Project Number: 5-C3532.00

# Te Ara Tupua

## Concept Design Road Safety Audit

Figure 41: Stage one and three layout of construction yard and active user path.

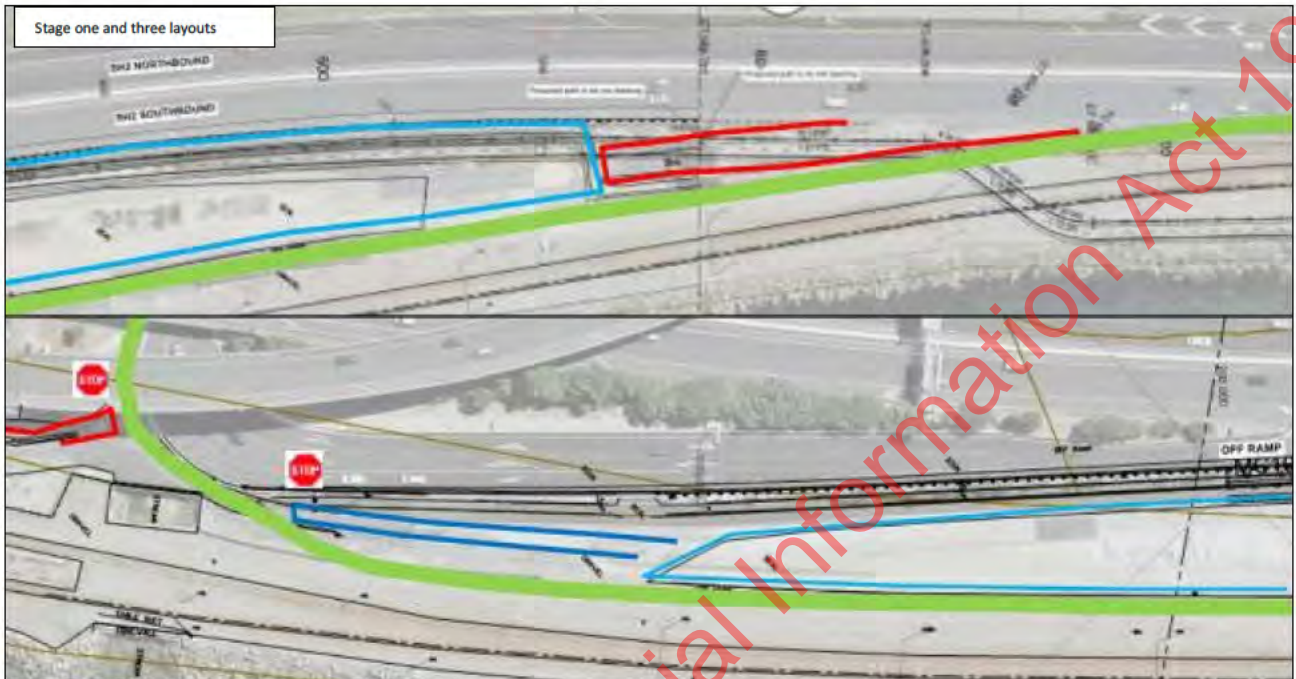
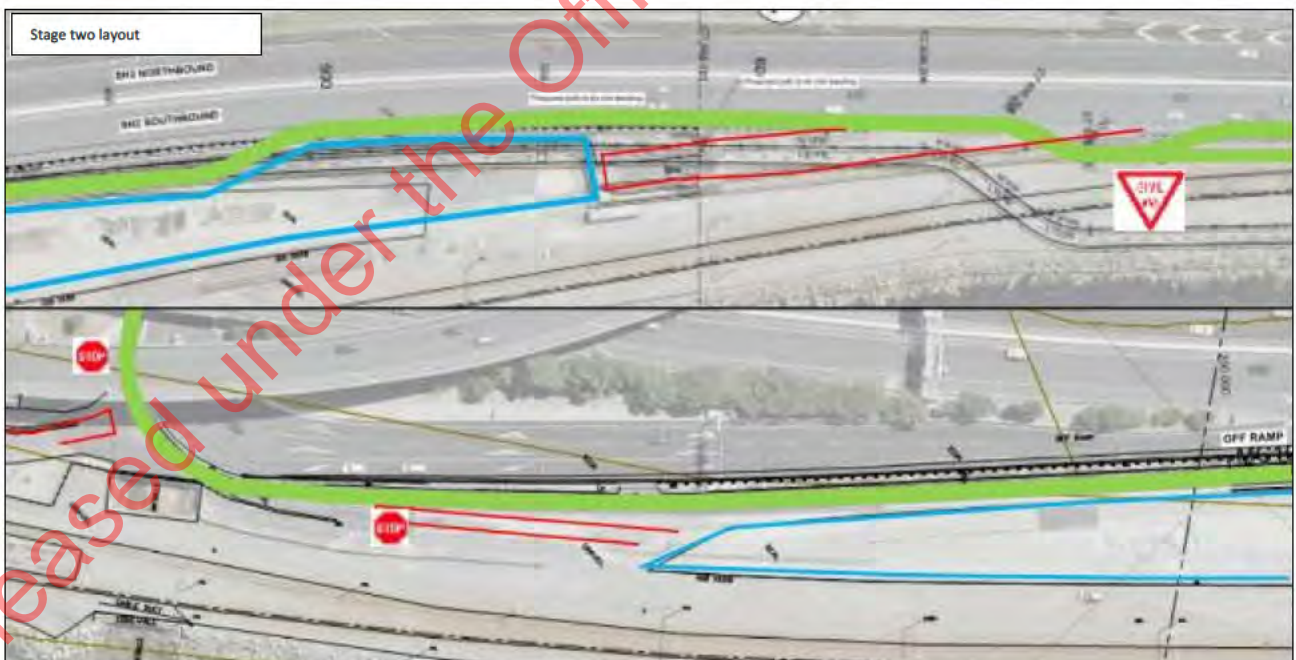
The stage one and three layouts remove conflict between path users and trucks at the ingress to the construction site. However, as trucks and other vehicles will be approaching the ingress at speed, the installation of a physical barrier, such as safe hit posts, could improve cyclist safety.

<b>Frequency:</b>	<b>Severity:</b>	<b>Rating:</b>
<i>Crashes are likely to be Infrequent</i>	<i>Death or serious injury is Likely</i>	<i>The safety concern is Moderate</i>
<b>Designer Response:</b>	The continued use of the SH2 access(es), path and connection to the existing path at Ngauranga has been recognised as a conflict zone which requires careful consideration and management by both the designers and the constructors. The details for the temporary management arrangements throughout each stage of the construction in these areas will be the responsibility of the Alliance and will subject to the relevant design standards and safety audit procedures.	
<b>Safety Engineer:</b>	Agree with SAT and Designer comment. Item to be addressed appropriately during detailed design and construction phases. Vulnerable user movements to be separated from construction activity, and where conflict remains, vulnerable users should be given priority through appropriate signage / devices / markings.

<b>Client Decision:</b>	<i>Agree with the comments above. This will be considered in the detailed design and planning of the works, by the designers, the constructors and the RCA</i>	
<b>Action Taken:</b>	[
